GW - 19

**GENERAL
CORRESPONDENCE**

CLAY LINED BRINE POND LOCO HILLS GSF, LTD. BUSINESS LEASE No. BL-635		PETTIGREW AND ASSOCIATES 1110 N. GRIMES HOBBS, NM 88240 (505) 395-9827	
BRINE POND DESIGN LOCO HILLS GSF, LTD. LOCO HILLS, NEW MEXICO		PROJECT# 2003.1016 DWG AutoCAD Loco Hills GSF.dwg BOOK#	
5	12/21/2004	REVISED	
4	11/17/2004	REVISED	
0	04/07/2003	FINAL PLAT	
00	03/14/2003	PRELIMINARY PLAT	
03/05/2003-03/06/2003	DATE OF SURVEY		DRN BY: C. JOHNSON
REV	DATE	DESCRIPTION	SHEET

RE: Loco Hills GSF, Discharge Plan
NW SW Section 22 Township 17S Range 29E

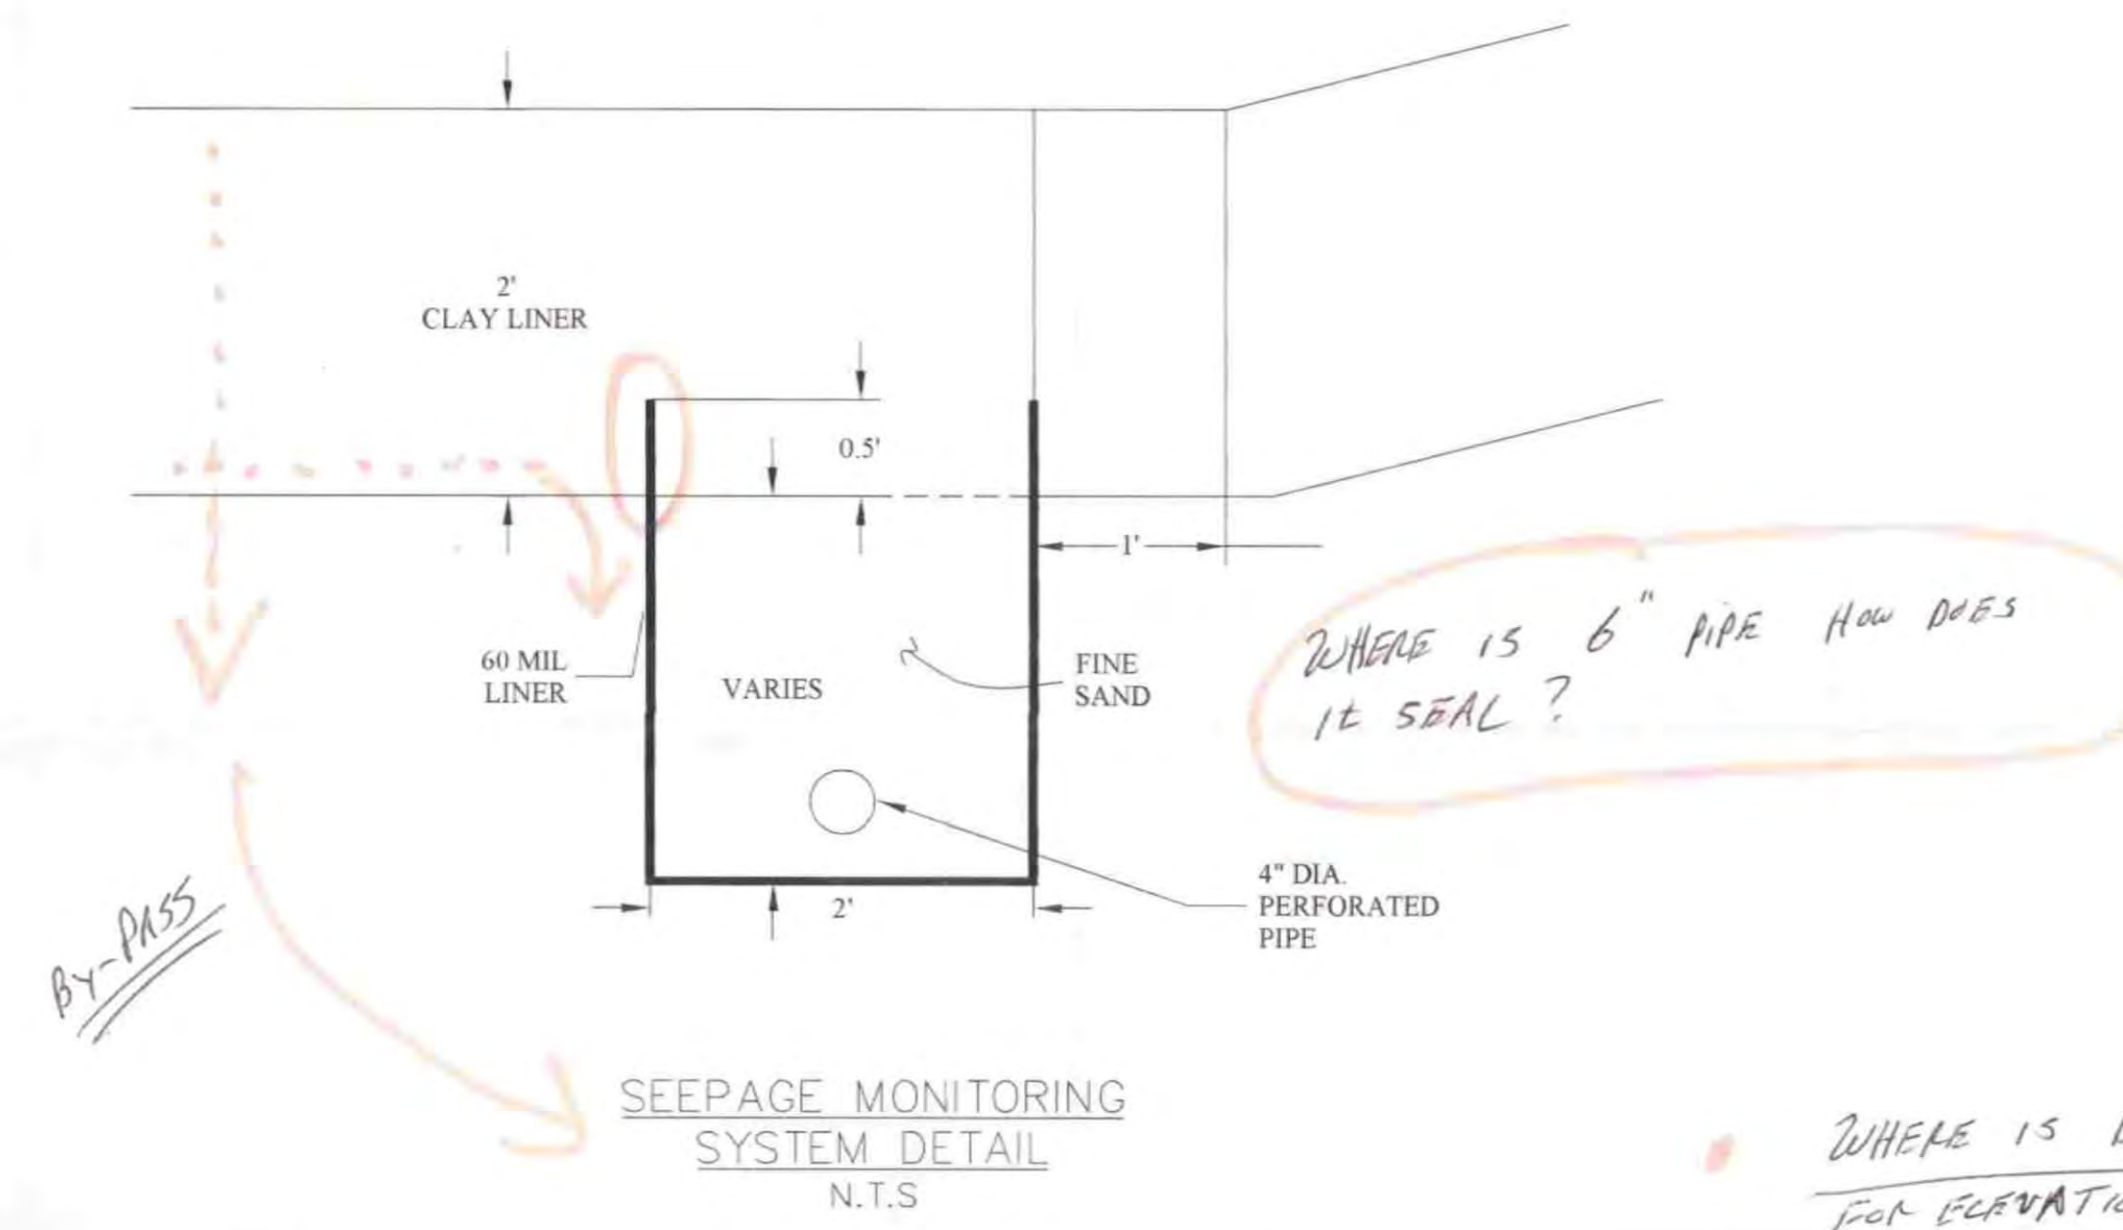
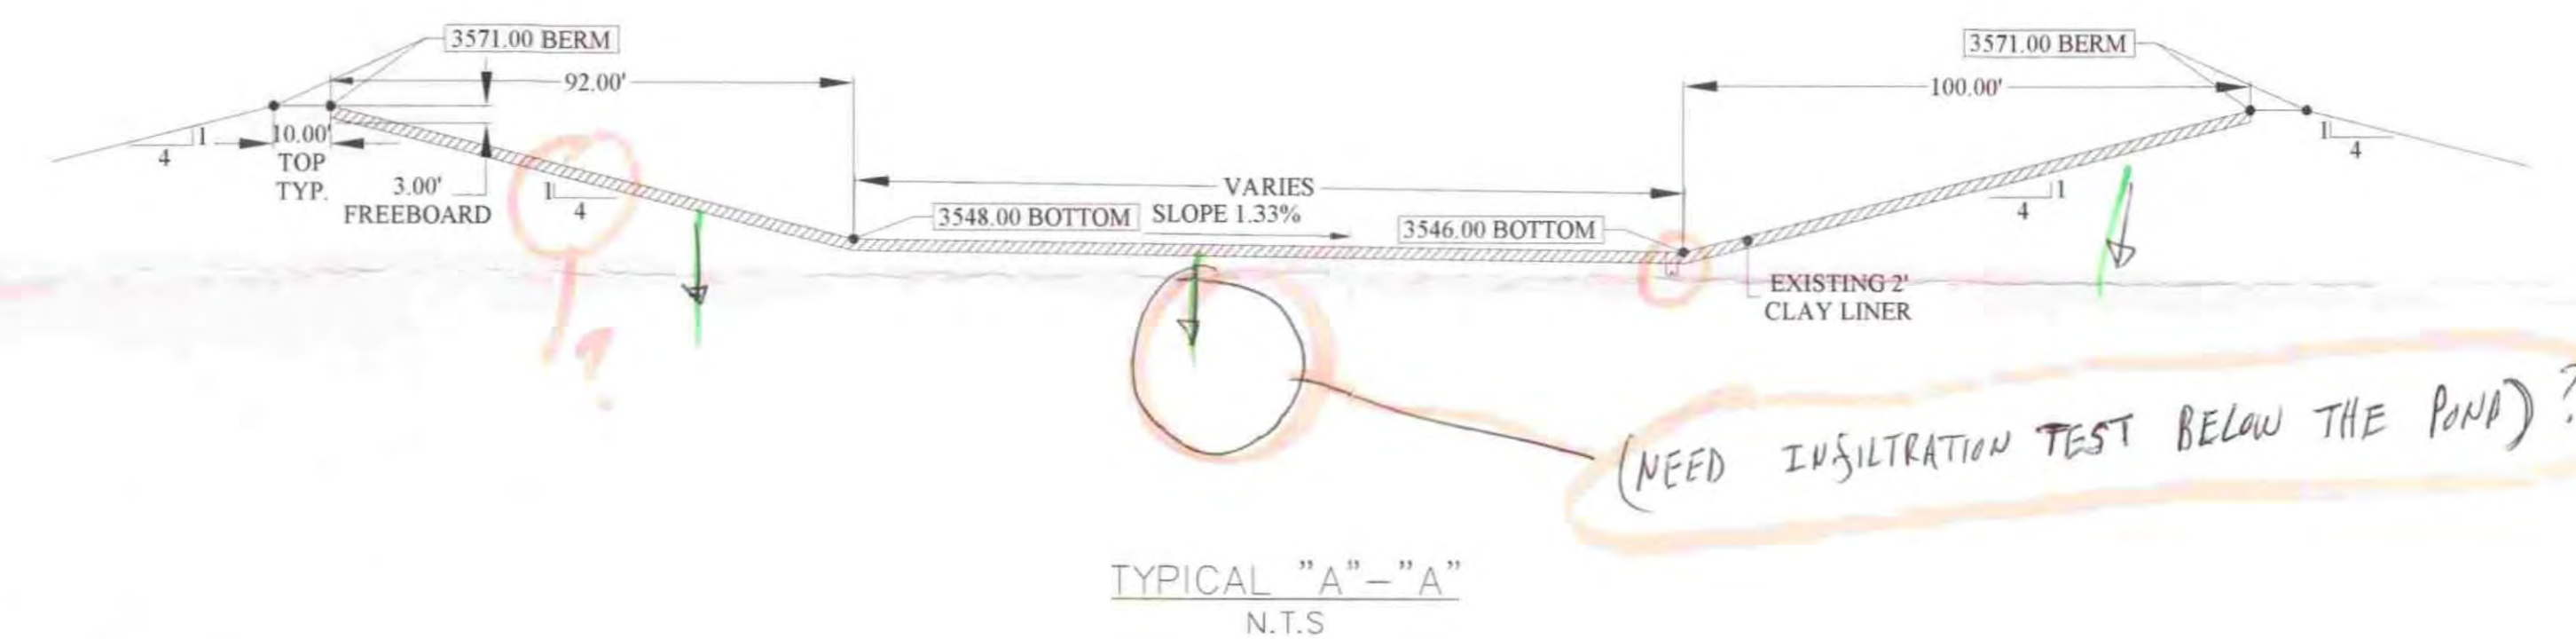
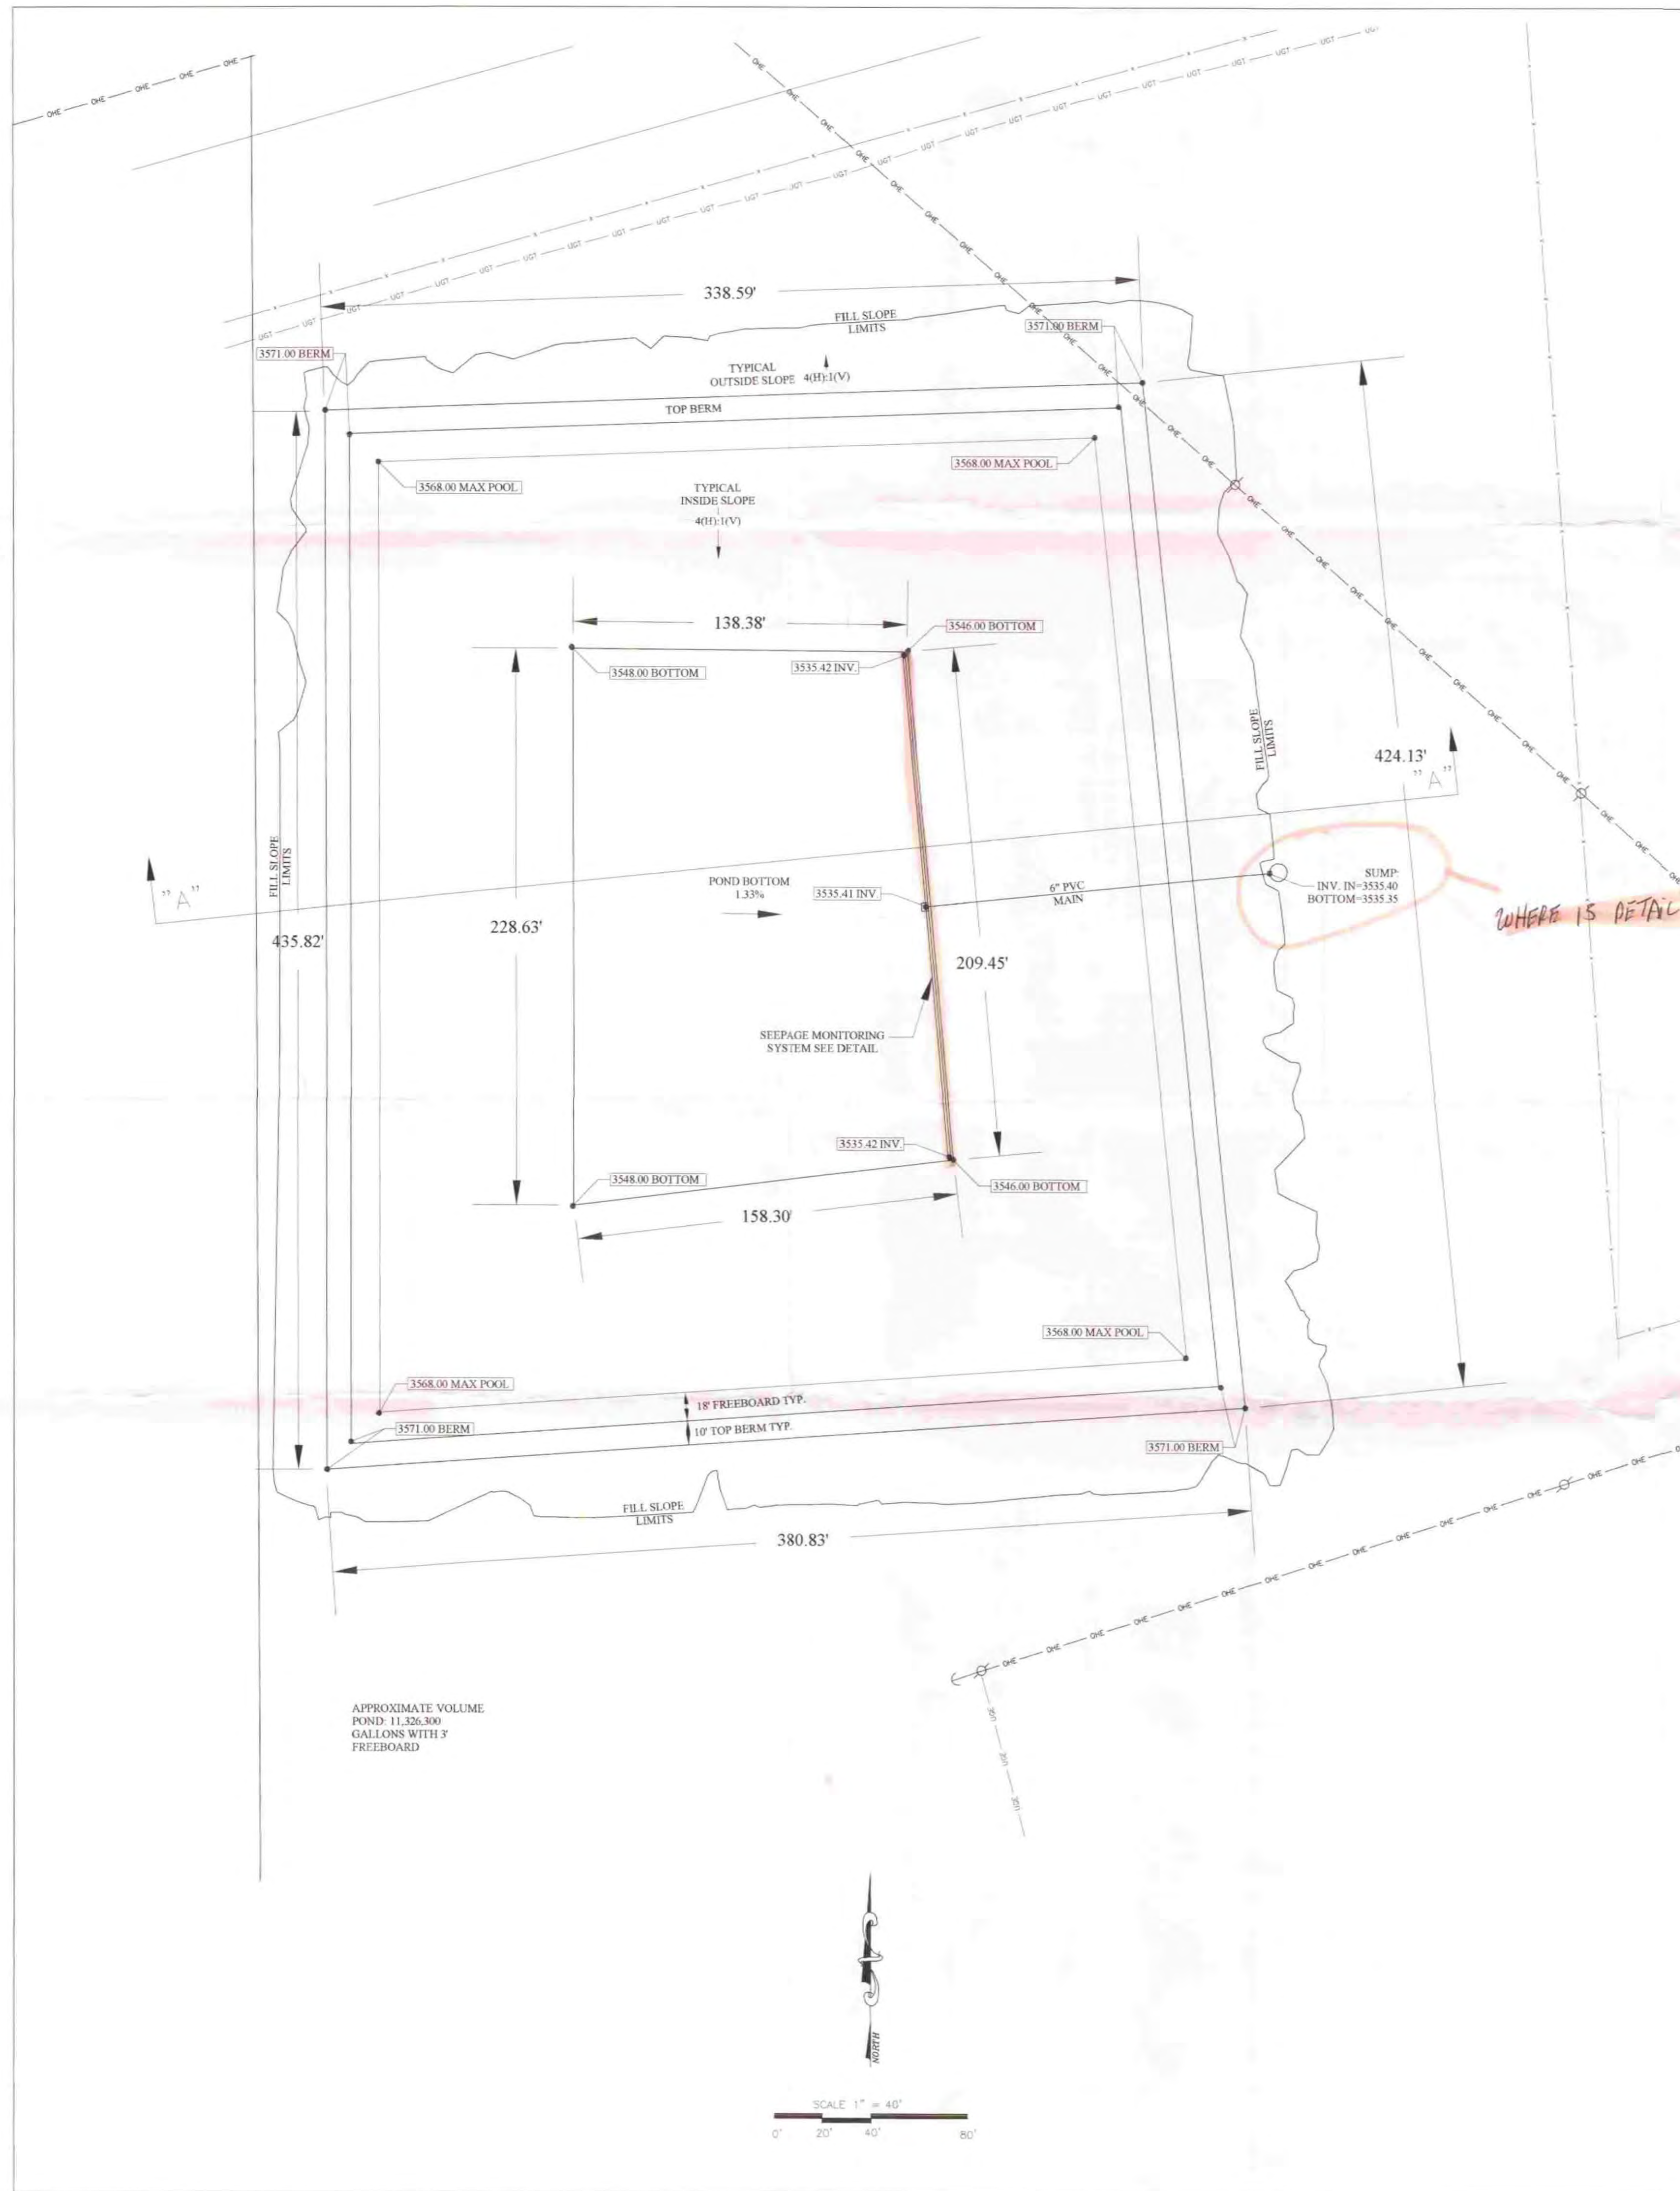
WILL THIS BE IN-SITU OR BATCH PROCESSING?

WHAT REQUIREMENTS WILL THEY REMOVE ROCKS?
